Attachment 1
Avocado Site Response

VENTURA COMPRESSOR STATION MODERNIZATION PROJECT

SOCALGAS

(Data Request 001)

Exhibit 1-2: North-facing view of the proposed temporary staging area

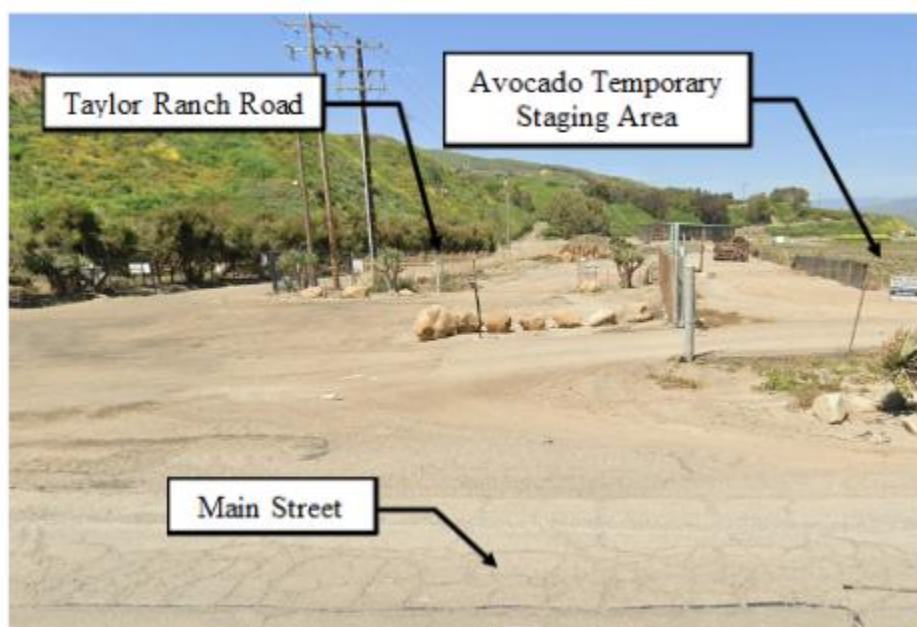
RESPONSE

The following photos in Exhibits 1-2 and 1-3 are from Google Earth aerial imagery (Street View) published in June 2025.

Exhibit 1-6: West-facing view of the Avocado Site and surrounding areas from across the valley

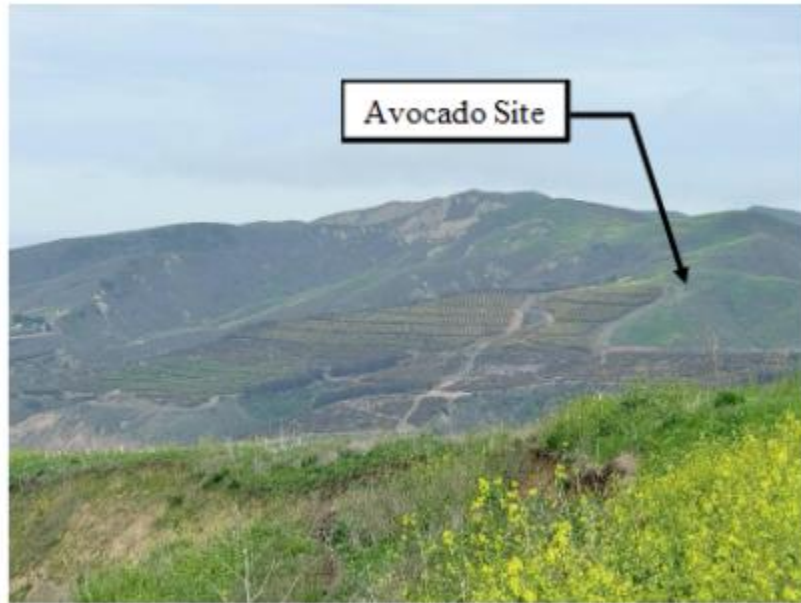
RESPONSE

The Avocado Site is situated on the hillside to the west of Highway 33 and the Ventura River. Immediately surrounding the site are native shrubs and plants on the north and west sides and avocado groves to the south and east, as shown on Exhibit 1-6.
